Appearance Review Board Staff Report

610 Lake Dot Circle Multi Unit Residential Building Courtesy Review

Case Number	ARB2025-10078
Applicant	Katie Liang
Owner	Alan Liang
Requested Action	Request for a Courtesy Review for a 3 unit apartment building at the front of the site.
Recommendation	Courtesy Review, no Board action required.
Project Planner	Richard Forbes, AIA Appearance Review Official

Site Plan

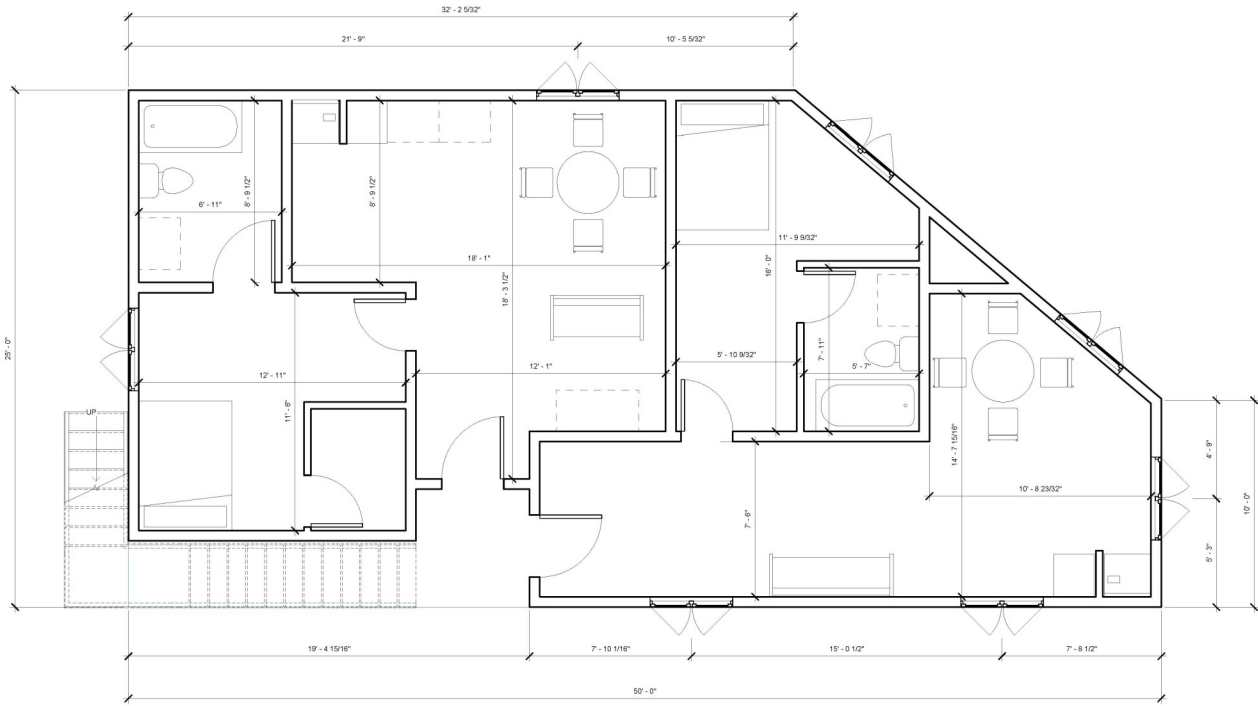
The site plan shows a water retention swale in the front yard that does not enhance the street frontage. The existing streetscape is Treatment 5 with what appears to be a six foot wide park strip and concrete sidewalk. Traditional City and the Parramore Heritage Overlay standards require a building entrance and entry porch features facing the street. The porch must be a minimum of 6 feet deep and cover 60 percent of the front elevation and connected by a sidewalk to the public sidewalk. The proposed building would be more compatible with the surrounding area if it were shifted back on the site at least 5 feet. The MU-1 zoning allows a 0 foot setback or through footnote 20 allows for a front yard setback of up to 15 feet. Pushing the building back would allow room to provide an interesting entry porch feature.

- vi. The building shall be shifted 5 feet west on the lot so that the proposed building is not as far in front of the structure to the north.
 - vii. The driveway is required to be setback a minimum of 2 feet from the north property line.

Floor Plans

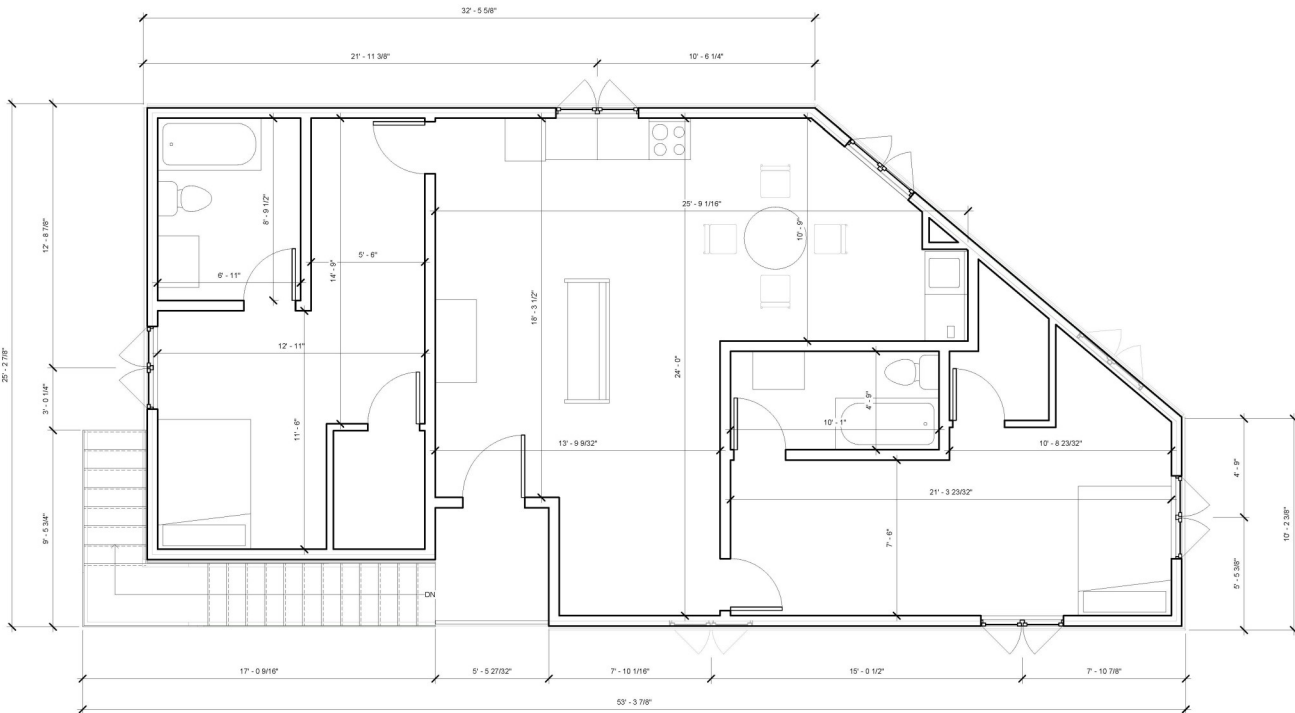
The ARB does not review interior arrangements, however, staff notes that the plan layout of the units is inefficient and not well planned. In addition, the interiors should be rearranged so that an entry and entry features are facing the street for the front ground floor unit.

East Elevation

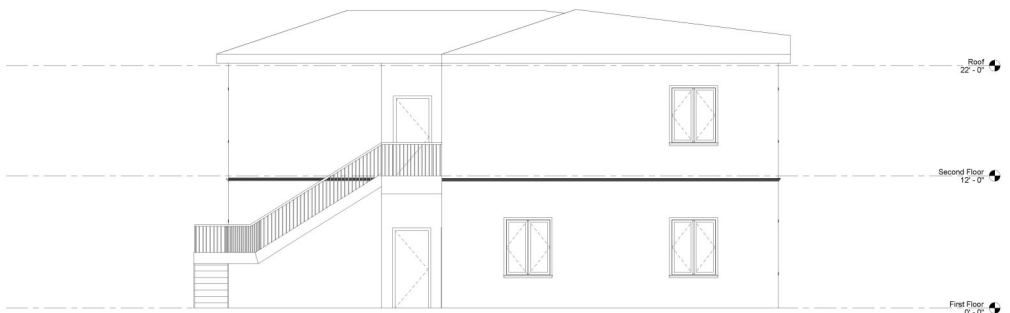
The architectural design of the building is undeveloped and needs additional refinement. The building should be oriented to the street with a porch and entry elements for the ground floor unit. The porch could extend to the second floor as well. Blank walls should be avoided. The required minimum transparency is 30 percent for the first floor and 15 percent on the second. The elevations show an unbalanced second floor fenestration arrangement and the windows should be similar and aligned on both floors. The plan notes show that the ground floor is concrete block and the upper level is frame construction. The windows should have the same inset on both the ground and second floor. Window trim and sills are required and the trim surrounding the windows should be consistent and compatible with the neighboring buildings. The proposed roof is shown as metal and that is similar to the school to the north but dissimilar to the immediate adjacent properties that have asphalt shingle roofing. The existing building on site is roofed with asphalt shingles and the wall material appears to be stucco over wood frame.

3. **Architecture**
 - A. Design—The design is not sufficiently developed and more detail is needed for final review.
 - i. The building is required to have an entry porch facing the street. The porch must be a minimum of 6 feet deep and cover 60 percent of the front elevation and connected by a sidewalk to the public sidewalk.

- ii. The design should share details and form with the previous structure and neighboring structures.
 - iii. The windows shall be symmetrical on both the ground and second floor and have the same inset on both floors and have appropriate sills and trim.
